Access Compliance Report

Public Rights-of-Way

(Pedestrian Signals)

Intersection ID: N/A	Main Street:	Cross Street: N/A	Location: N/A
ADA ID: D09D8480B205	Signal Type: One Push Button-Non APS	Overall Compliance: No	Severity Score: BTN 1: N/A BTN 2: N/A No BTN: N/A
Codes/Mitigation Info/Possible Solution		Field Measurements/Component Compliance

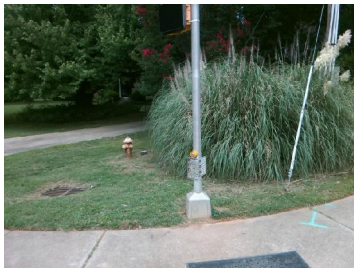
Possible Solutions: Provide Push Button Extension. Remove and Replace Clear Space.

PROW/ADA: R404.2, R406.2
